# UNITED STATES PATENT AND TRADEMARK OFFICE

APPLICATION NO.	FILING DATE	FIRST NAMED INVENTOR	ATTORNEY DOCKET NO.	CONFIRMATION NO.
10/679,156	10/03/2003	Frederick H. Grenning	5320/55488	3953

**Office Action Summary**

Fig. 1

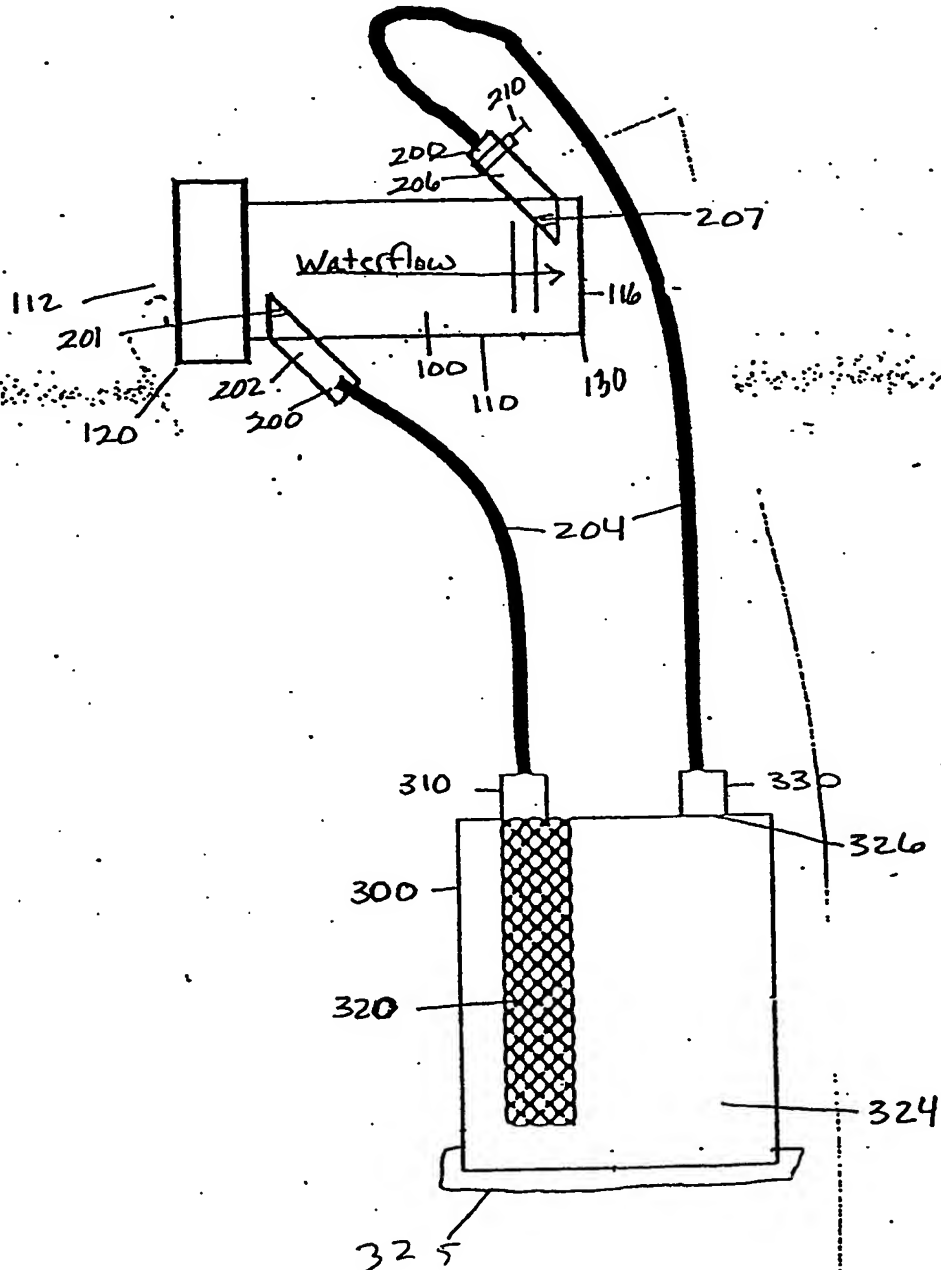
which is not supported by the original disclosure is as follows: the removable access cap 325 added to FIG. 1 and 325a added to FIG. 4 is new matter; the limitations relating to the access cap added to pages 13, 14, 16, and 18 of the specification.

Do not enter  
ms

Applicant is required to cancel the new matter in the reply to this Office Action.
